PROJECT TITLE: Four-1 : Apartment Bldg. ZONE ATLAS/DR FILE #: K-16 1035LEGAL DESCRIPTION: Lot 21, Block 18, University Heights AdditionCITY ADDRESS: 207 Princeton Drive, S.E.ENGINEERING FIRM: Lovelady & Associates CONTACT: Frank LoveladyADDRESS: 7408 Morrow Ave. NE 87110 PHONE: 883-7973OWNER: Don Keith & Associates CONTACT: Don KeithADDRESS 7116 Edwina Ct. NE PHONE: 884-4070

RE: REVISED DRAINAGE PLAN FOR FOUR PLEX APARTMENT BUILDING
207 PRINCETON AVENUE, SE (K-16/D35)
REVISION DATED MAY 12, 1989

GRADING AND DRAINAGE PLAN
FOUR-PLEX APARTMENT BUILDING
207 PRINCETON DRIVE, S.E.
ALBUQUERQUE, NEW MEXICO

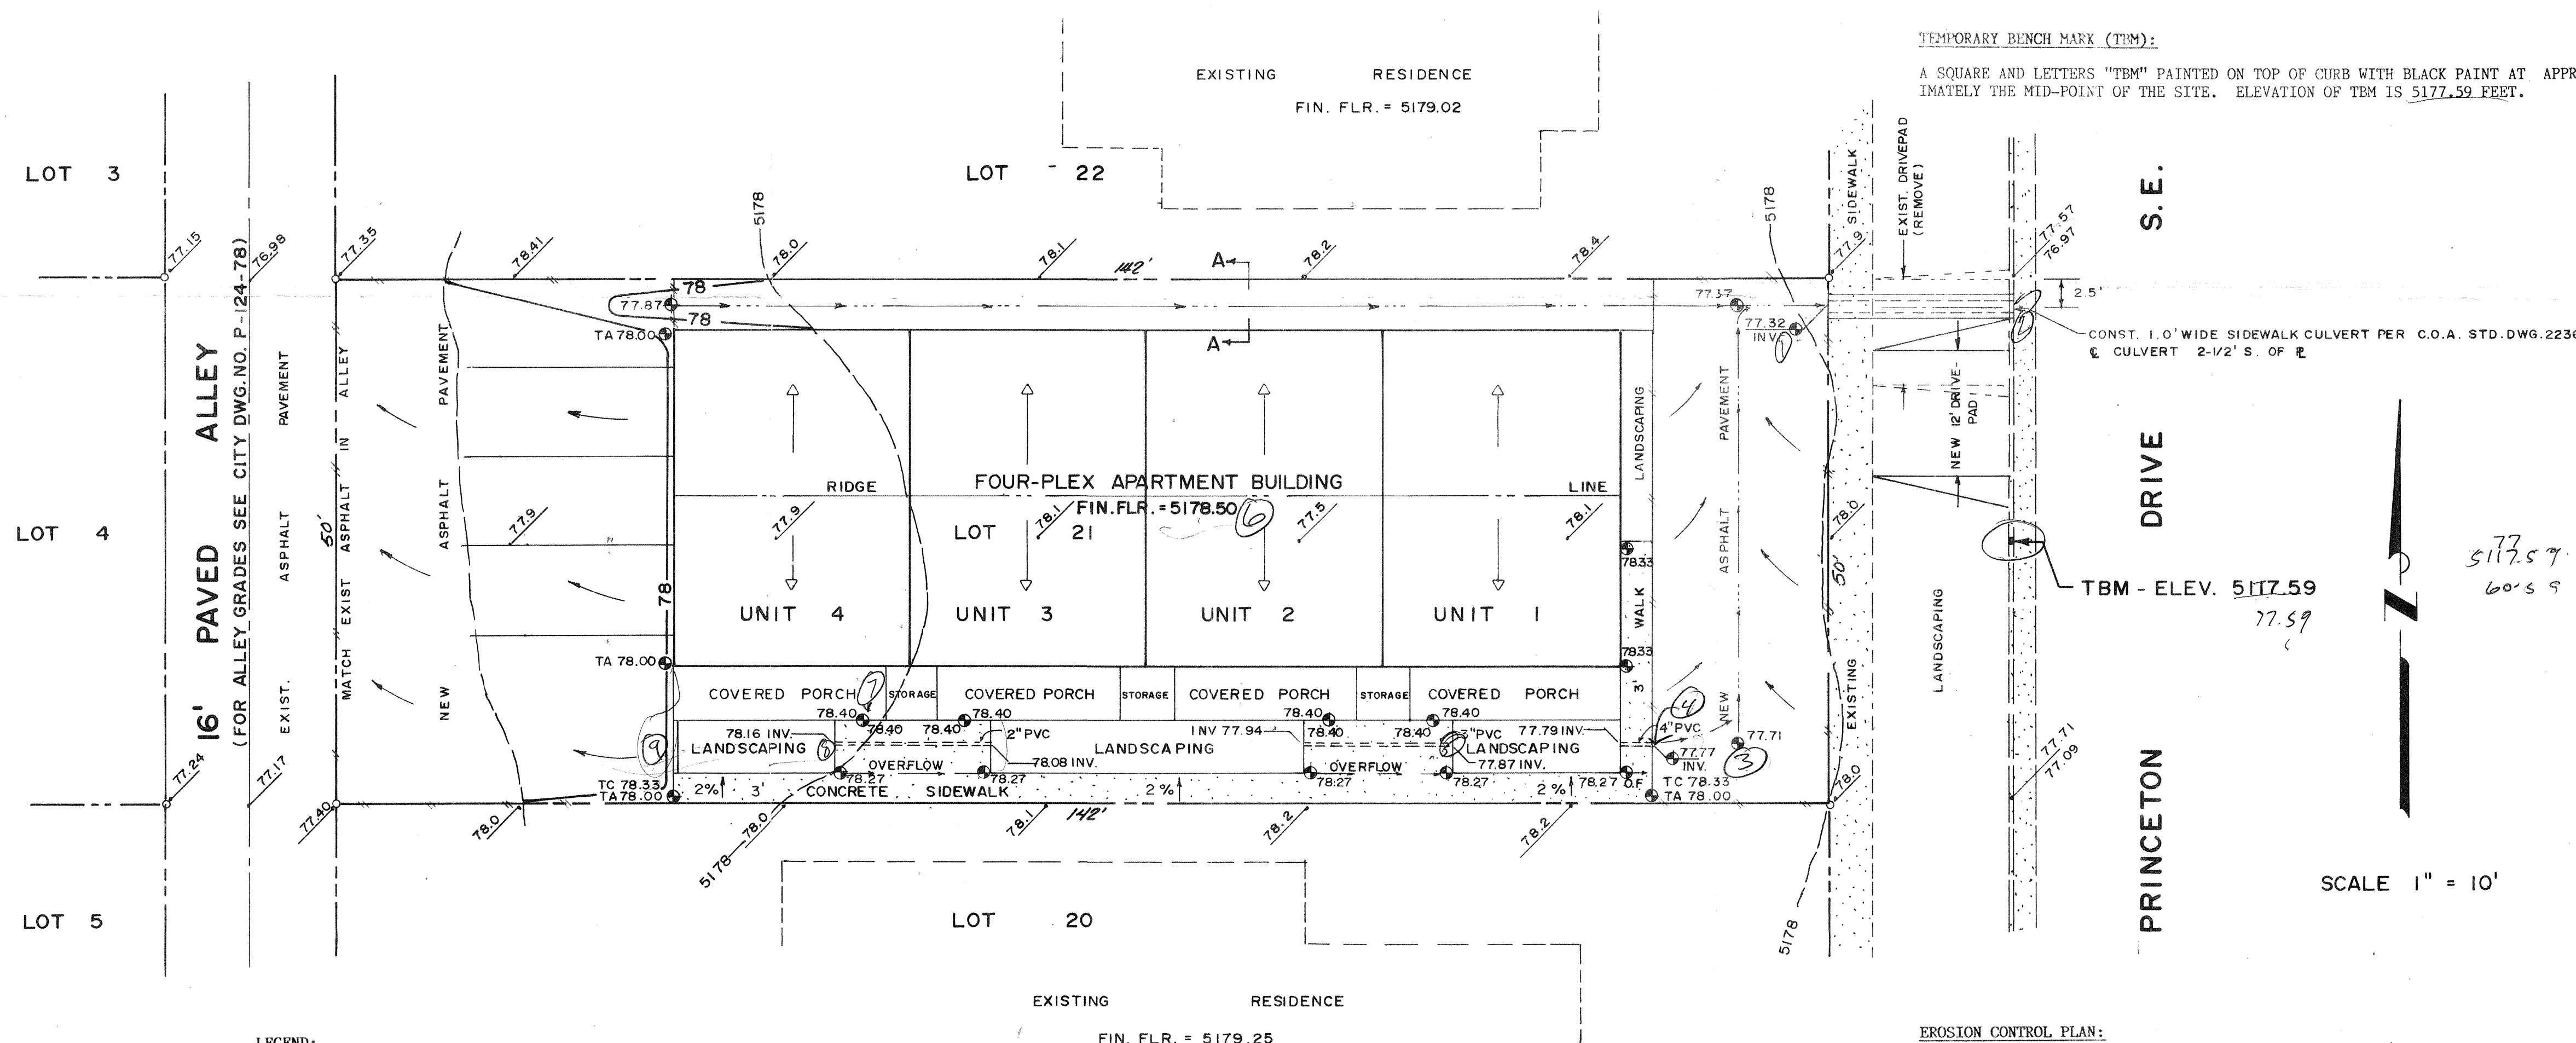
Based on the information provided on your resubmittal of May 16, 1989, the revisions as indicated are acceptable for Building Permit.

- DRAINAGE PLAN PER D.P.M. GUIDELINES REQUIRED PRIOR TO BUILDING PERMIT RELEASE.
- FREE DISCHARGE TO PRINCETON IS ACCEPTABLE.
- FREE DISCHARGE TO ALLEY IS ACCEPTABLE IF ALLEY IS PAVED AND HAS CAPACITY ALL THE WAY TO MAIN STREETS. PROVIDE VERIFICATION WITH DRAINAGE SUBMITTAL.
- APPROVED ALLEY GRADES ARE REQUIRED TO COMPARE WITH SITE GRADES.
- ALLEY FLOWS ARE FROM SOUTH TO NORTH.
- IDENTIFY ANY OFF-SITE FLOWS ENTERING THE SITE.

☐ DRAINAGE REPORT☒ DRAINAGE PLAN☐ CONCEPTUAL GRADING & DRAIN. PLAN☐ GRADING PLAN☐ EROSION CONTROL PLAN☐ ENGINEER'S CERTIFICATION☒ Revised Plan - lowered
Fin Flr. 6"DATE SUBMITTED: April 21, 1989BY: Frank D. Lovelady, P.E.

- THE D.P.M. GUIDELINES WERE USED IN PREPARATION OF THIS GRADING AND DRAINAGE PLAN.
- THE SITE HAS BEEN GRADED TO DRAIN MOSTLY TO PRINCETON DRIVE TO MINIMIZE DISCHARGE TO THE ALLEY.
- THE AMOUNT OF FLOW DISCHARGING TO THE ALLEY WILL BE REDUCED AFTER DEVELOPMENT. THE ALLEY IS PRESENTLY PAVED.
- APPROVED ALLEY GRADES ARE PER CITY PROJECT P-124-78. ONLY CENTERLINE GRADES ARE SHOWN ON THE PLAN AND PROFILE AND THERE IS NO TYPICAL SECTION.
- FIELD ELEVATIONS CONFIRM THAT ALLEY FLOWS ARE FROM SOUTH TO NORTH.
- THERE ARE NO OFF-SITE FLOWS ENTERING THE SITE. ALL LOTS DRAIN EITHER TO PRINCETON OR THE ALLEY. THERE IS NO SIGNIFICANT CROSS-LOT-LINE DRAINAGE.
